ADDENDUM 2

T-12 IFB Derby Street Park, 289 Derby Street Salem, MA

Date: October 5, 2017

CRUSHED STONE DRIP EDGE - R1
NO SCALE

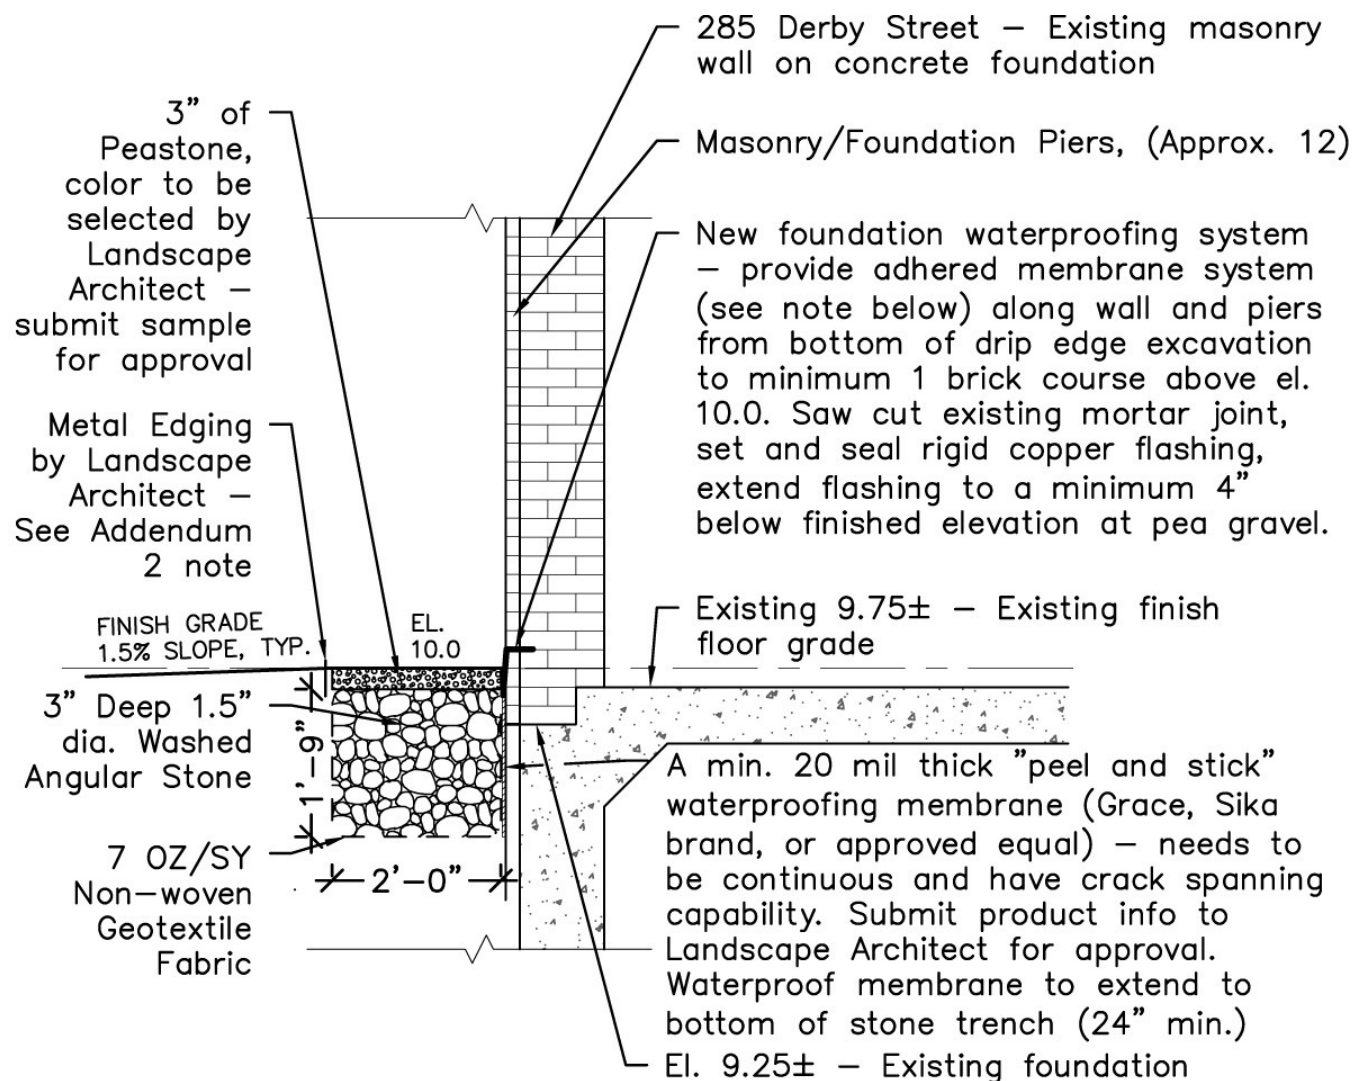
On sheet C2 the "Crushed Stone Drip Edge" detail is to be replaced with the below detail titled "Crushed Stone Drip Edge - R1". The Metal Edging indicated in this detail is to be Steel, measuring 1/4" x 5", secured with 15" long stakes by Ryerson (or approved equal). Color of Metal Edging to be black or silver metal.
